The following letter and revised drawings respond to your review and comments for 53<sup>rd</sup> and Tennyson Row project at 4301 W. 53<sup>rd</sup> Ave, Log number PRC2020-00005. Responses are listed below in **red**. Please call or email if you have any questions or require additional information.

# 53RD AND TENNYSON ROW - LANDSCAPE PLAN

# Comment Response

The following letter responds to your plan review and comments for the project at **4301 W. 53<sup>rd</sup> Avenue, Denver, CO 80212**, Application #PRC2020-00005 and EGR2020-00007. Responses are listed below in **red**. Please call or email if you have any questions or require additional information.

A PART OF THE NORTHEAST ¼ OF SECTION 18, TOWNSHIP 3 SOUTH, RANGE 68 WEST OF THE 6TH P.M.  
CITY OF DENVER, COUNTY OF ADAMS, STATE OF COLORADO.  
(LOCATED AT: 4301 WEST 53RD AVENUE, DENVER, CO 80212.)

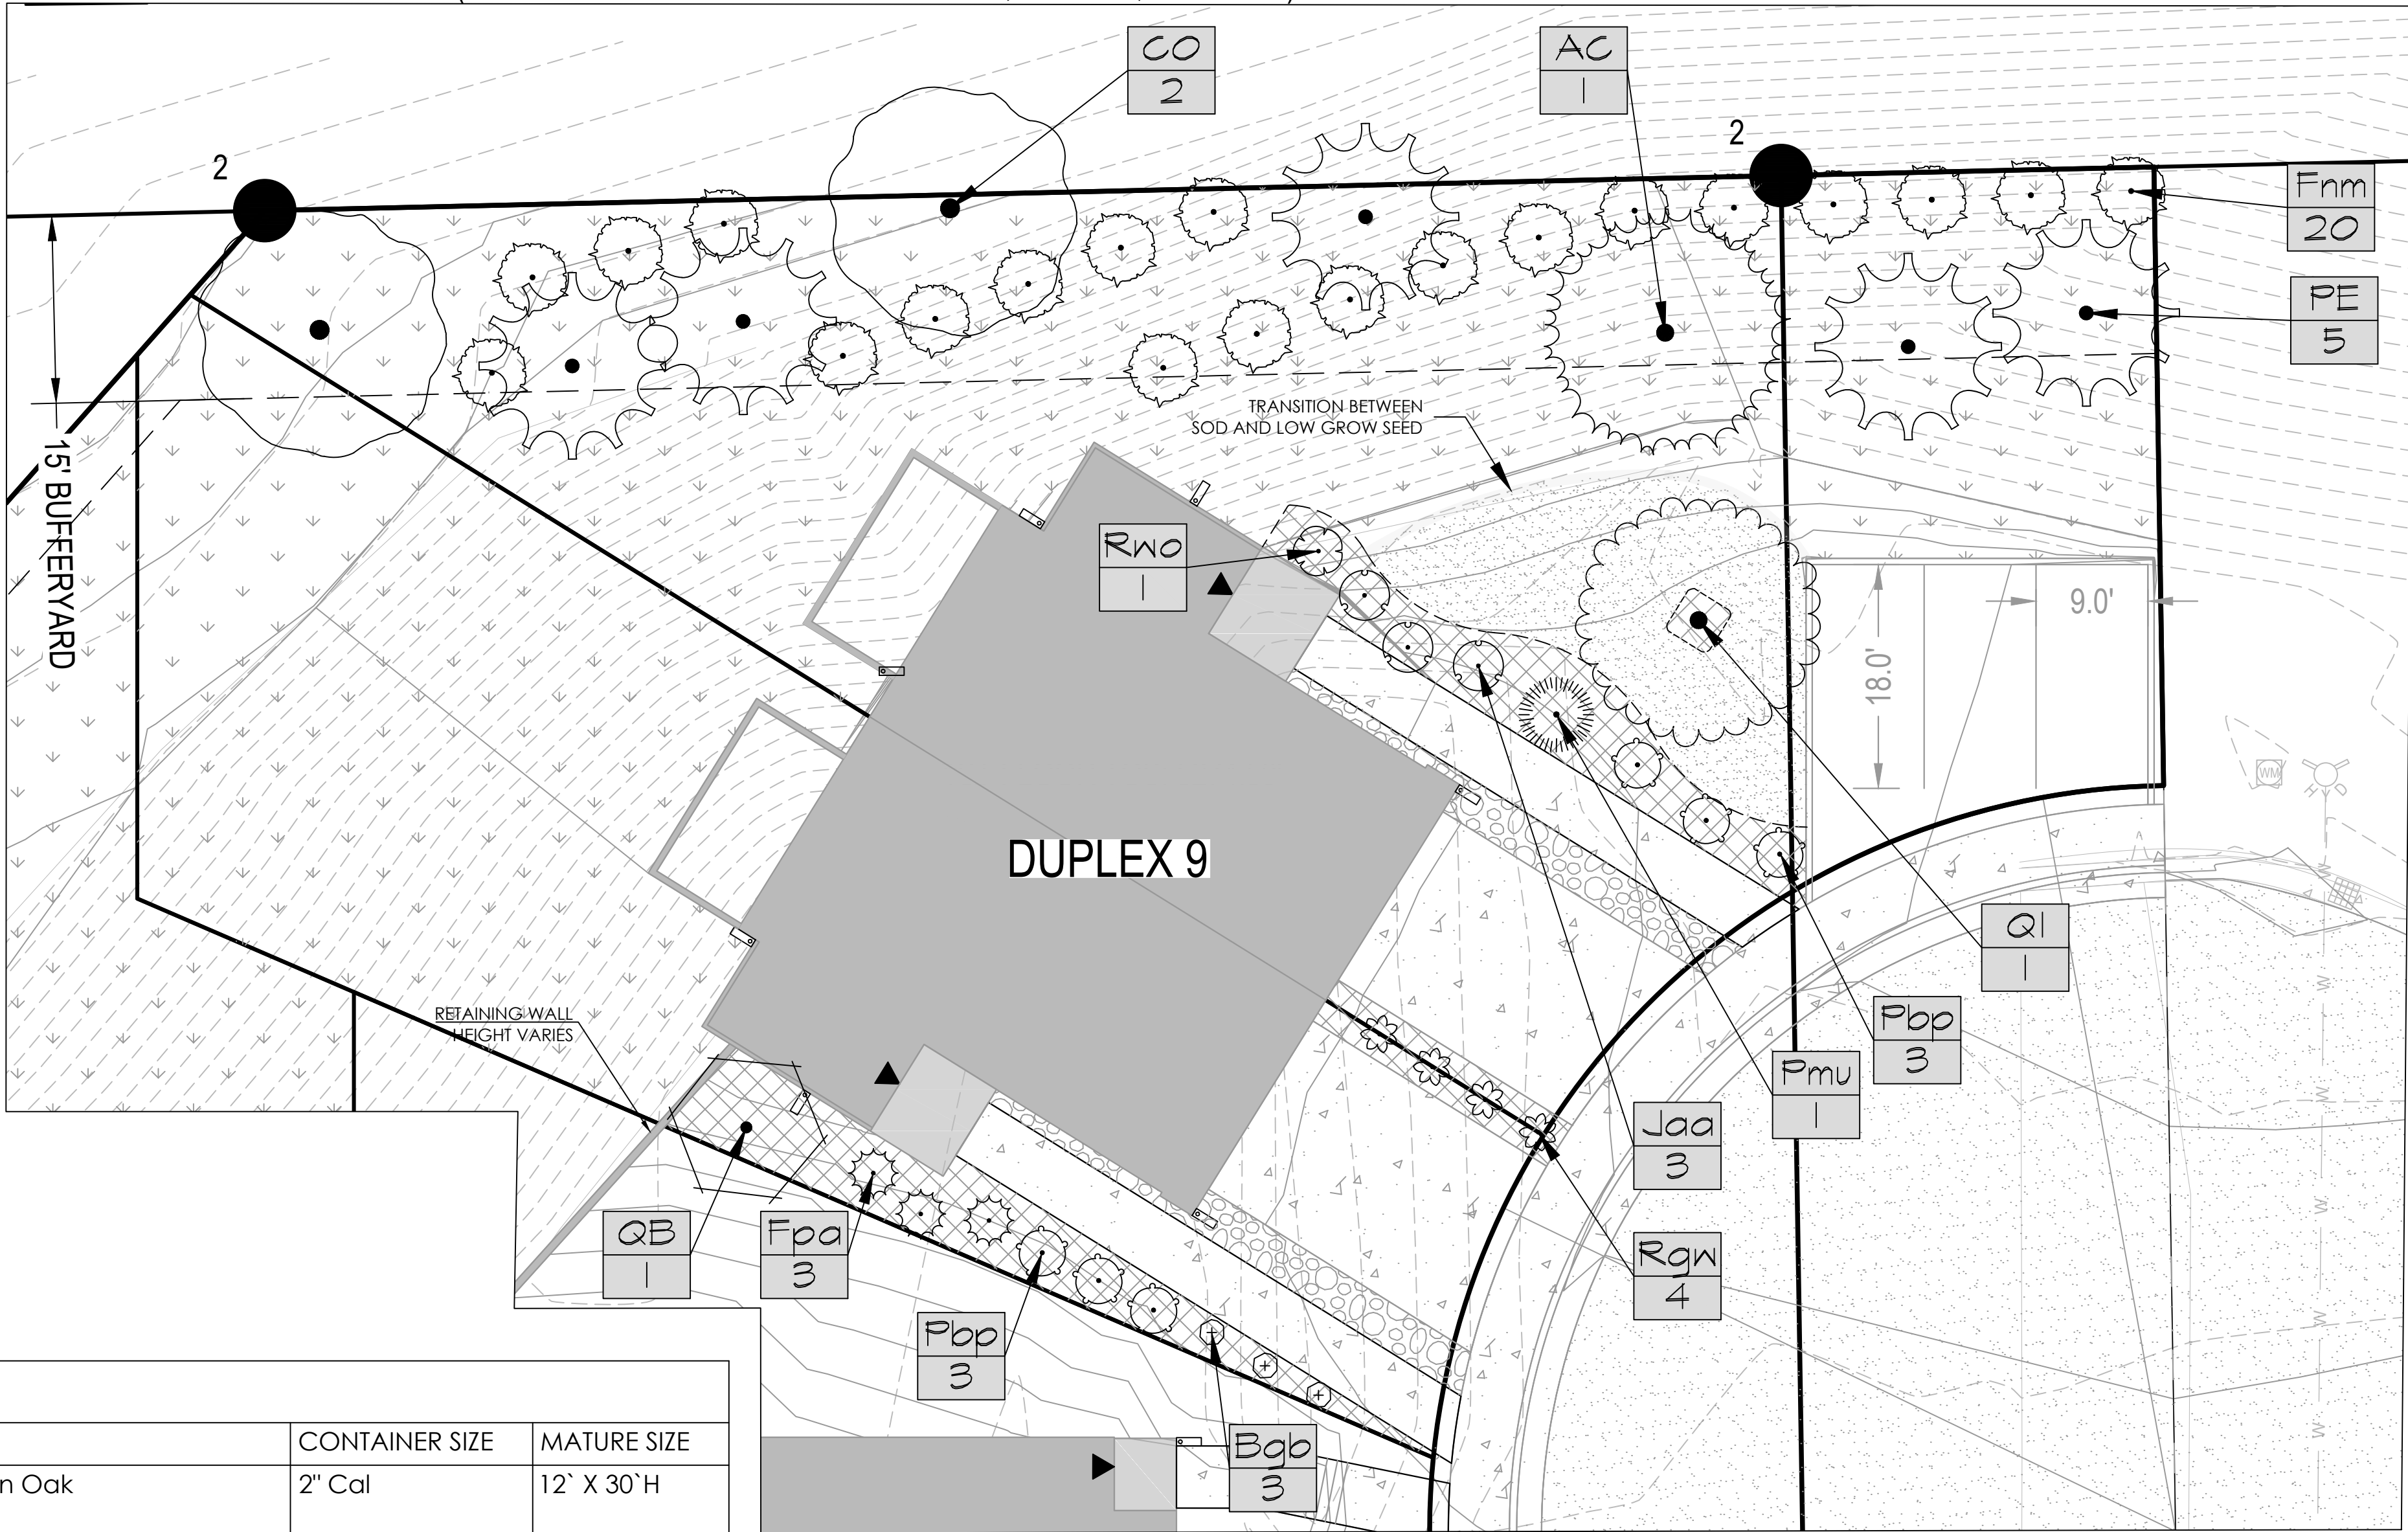
- iii. Please include individual lot calculations with Landscape Plan

*Response: Individual lot calculations have been included on the landscape plan.*

*Response: Three lot typical examples are included on Sheets LS-3 and LS-4.*
